**B2.1.1**

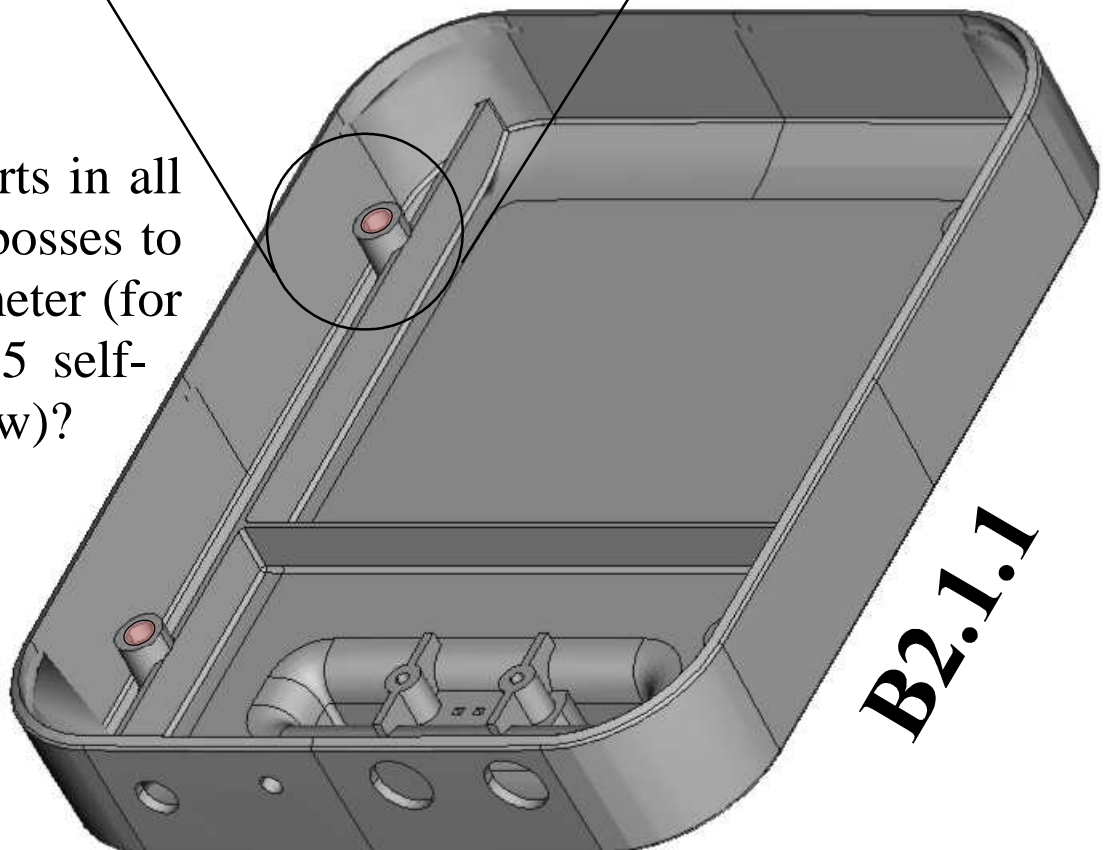
Reduce inserts in all  
screw hole bosses to  
2.2mm diameter (for  
smaller M2.5 self-  
tapping screw)?
